Technical Service Bulletin

Subject: RUST AROUND REAR VIEW CAMERA AND/OR LIFTGATE OPENER SWITCH	Bulletin No.: 09-004/20
	Last Issued: 01/10/2020

This bulletin supersedes the previously issued bulletin(s) listed below. The changes are noted in Red text.

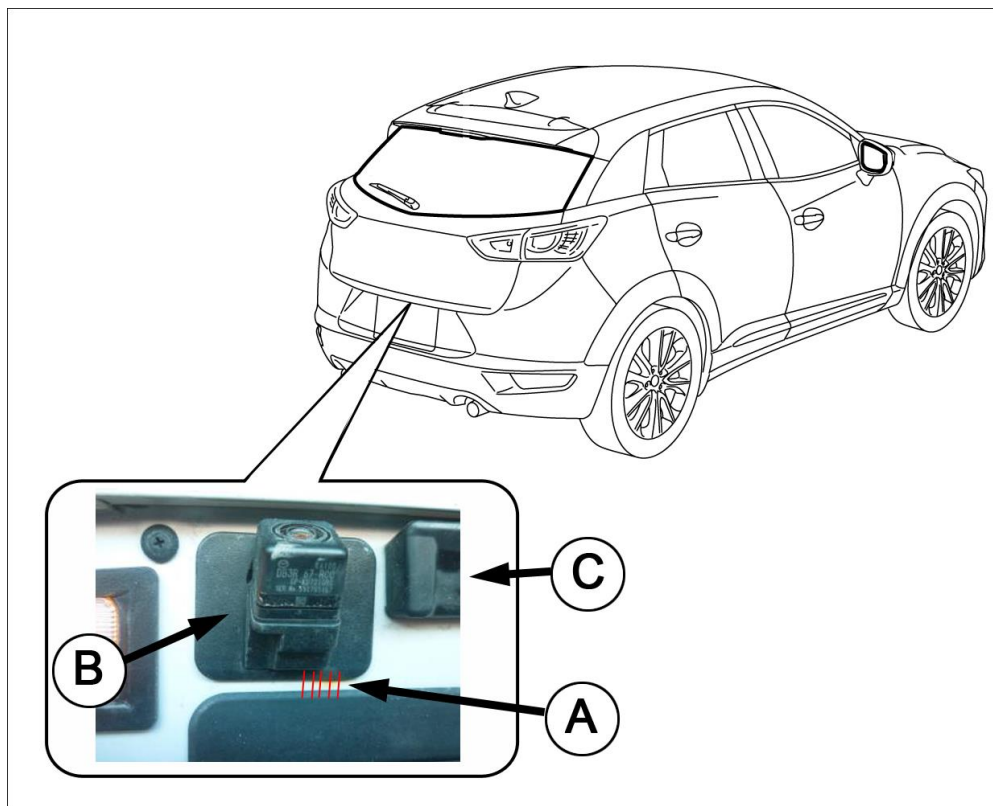
Some vehicles may exhibit rust (A) on the liftgate around the border of the rear mount camera (B) and/or the liftgate opener switch (C). Repair the paint rust and install a pad to prevent future paint rust.

A	Protector Film
B	Installation Hole for Rear Mount Camera
C	Installation Hole for Liftgate Opener Switch

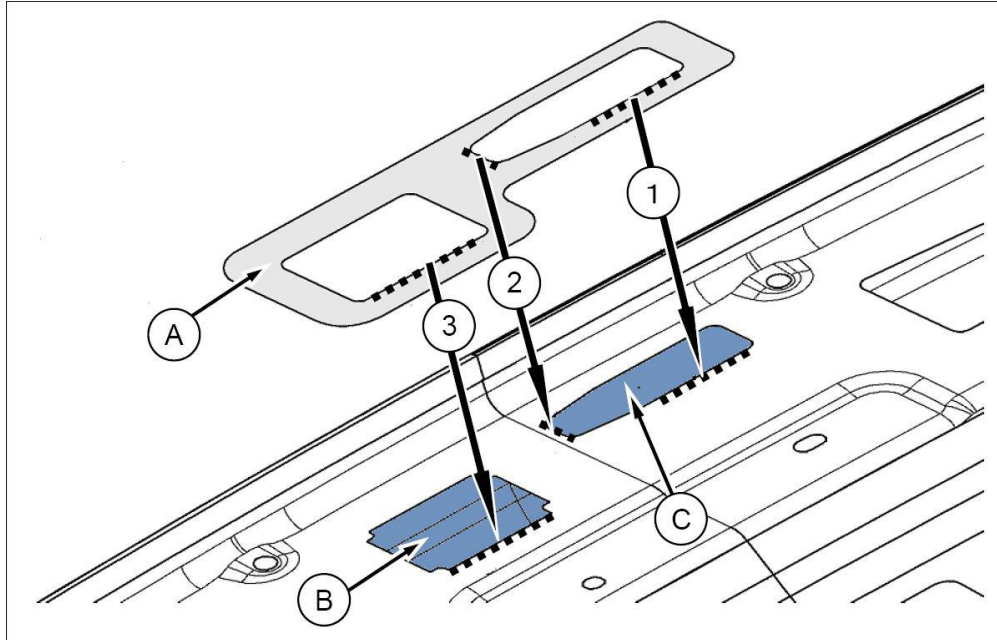
3. To prevent direct interference of the rear mount camera and liftgate opener switch mount bases with the liftgate paint surface, attach a protector film (DBY0-62-864) to the liftgate.

- Degrease the liftgate where the protector film is attached.
- The protector film (A) must not cover the installation holes for the rear mount camera (B) and liftgate opener switch (C). To attach the protector film in the correct position, first align three edges (marked with 1 - 3 in figure) of the protector film with three edges (marked with 1 - 3 in figure) of the installation holes, and then attach the whole protector film without leaving air bubbles.
